AMF | HARLEY-DAVIDSON SERVICE BULLETIN

M-822

March 31, 1981

1981 FXB STARTER SOLENOID

Figure 2. Solenoid — Exploded View

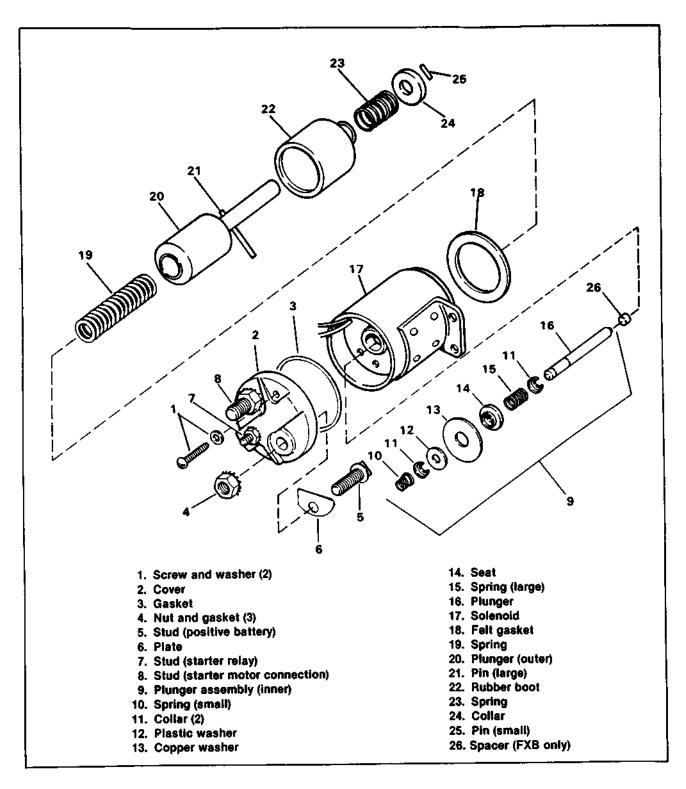
In 1981 model production, a spacer was added to approximately 50% of the FXB starter solenoid assemblies. At this time the spacer does not have a part number nor is it shown in either the Parts Catalog or Service Manual.

See Figure 2. The spacer (26) is required so that the inner plunger on certain models will travel far enough to allow the copper washer (13) to make contact between the battery terminal (5) and the starter motor terminal (8) of the starter solenoid, thus actuating the starter motor.

Should the spacer become lost during disassembly of the solenoid or an FXB is experiencing a problem where the solenoid is operating but not allowing current to flow to the starter motor, fabricate a spacer out of common low carbon steel rod (see Figure 1) and install it in the starter solenoid, as shown in Figure 2.

Do not use this spacer in a starter solenoid that is functioning properly.
